PRODUCT CHANGE NOTIFICATION

Bourns® Model 3362R, H and U Style 1/4-Inch Square Single-turn, Through-hole Trimpot® Trimming Potentiometer

Housing Appearance Changes

T2415

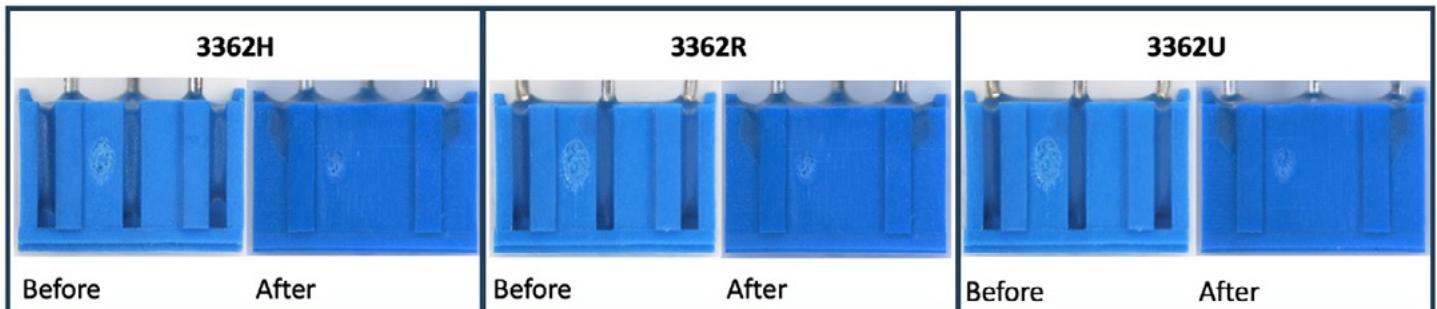
Riverside, California – September 26, 2024 – Bourns is pleased to announce that in the spirit of continuous improvement, effective November 8, 2024, the housing terminal exit area of the [Model 3362R, H, and U Pin Style Trimpot® Trimming Potentiometers](#) will be updated. This update removes the lead exit on the top adjust models, providing a cleaner look to the product. This change does not affect the fit, function, reliability or quality of these models. The only change is on one of the four sides of the housing. Currently, the lead exit is open. After the change, the lead exit will be closed. Please review the pictures below.
